ENERGY NORTHWEST

Columbia Generating Station

Regulatory Conference

Emergency Plan Implementing Procedure
Guidance

DECISION GUIDE FOR OFFSITE PROTECTIVE ACTION RECOMMENDATIONS

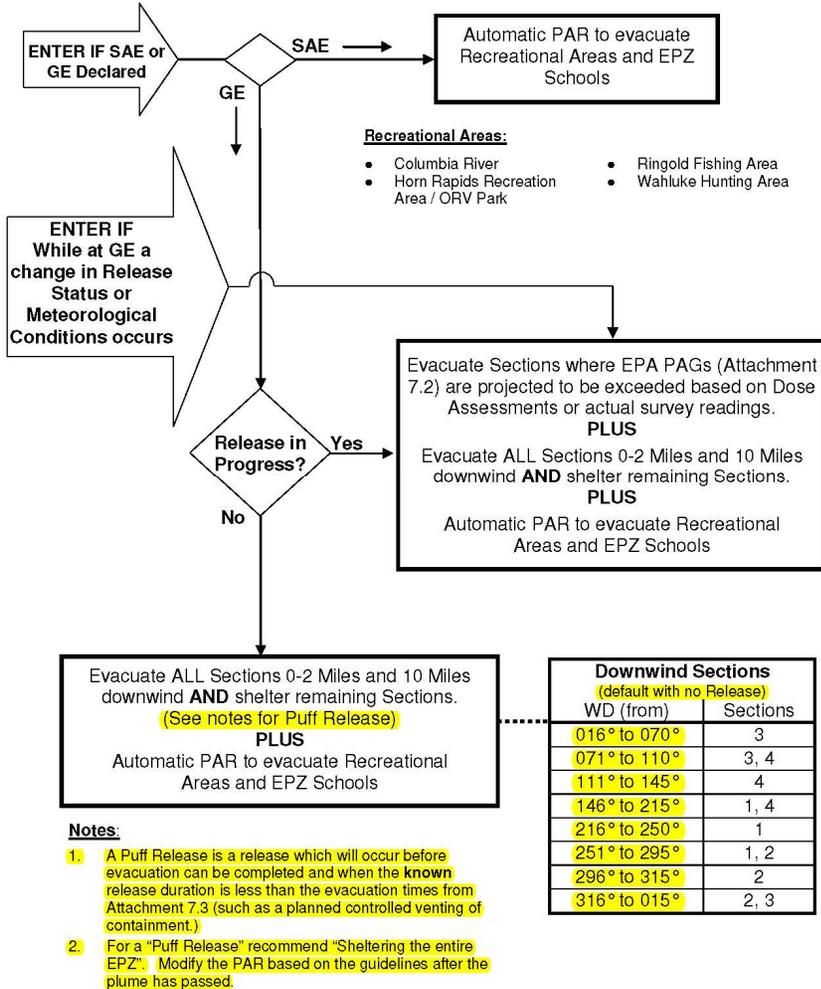
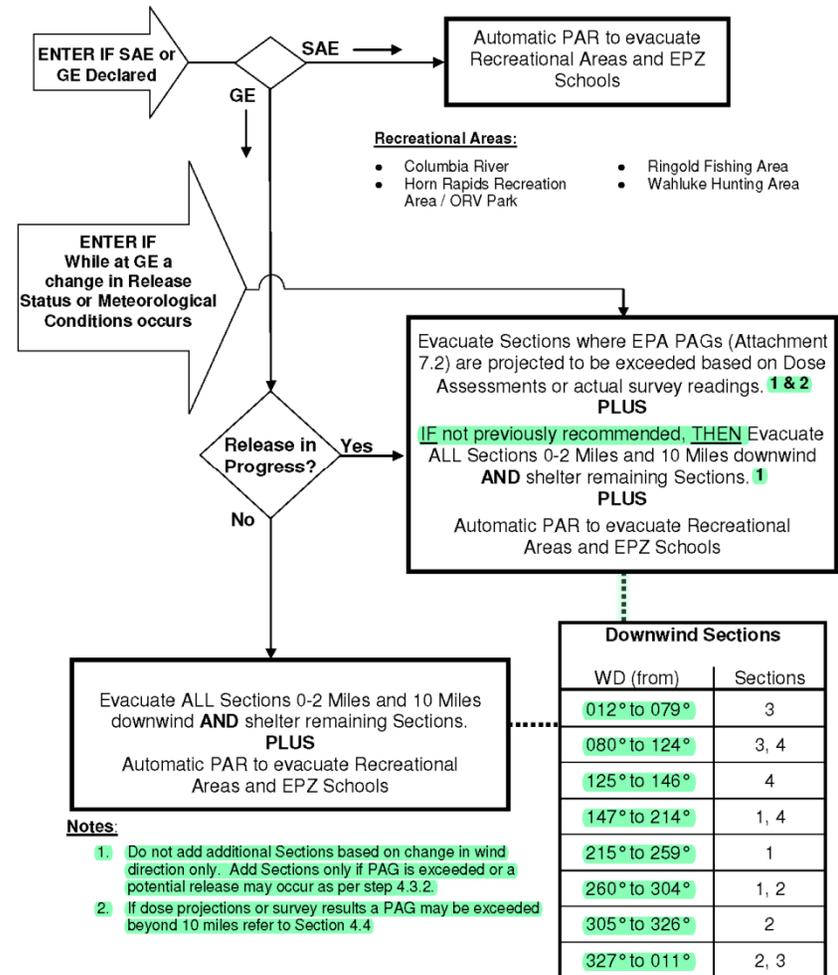
- No longer provided a mechanism to make a shelter-in-place protective action recommendation;*
- No longer ensured a protective action recommendation in the event of a planned release of radioactive material;”*

- *No longer provided a mechanism to make a shelter-in-place protective action recommendation”*

- *No longer ensured a protective action recommendation in the event of a planned release of radioactive material”*

A mechanism for making a shelter-in-place protective action recommendation is provided via Attachment 7.1 and 7.2 of PPM 13.2.2 Revision 18.

A protective action for planned releases of radioactive materials is developed using Attachment 7.1 and 7.2 of PPM 13.2.2 Revision 18. In addition steps 4.2.2 (initial PAR) and 4.4.6 (updated PAR) ensure that notifications for a planned release of radioactive material are made.
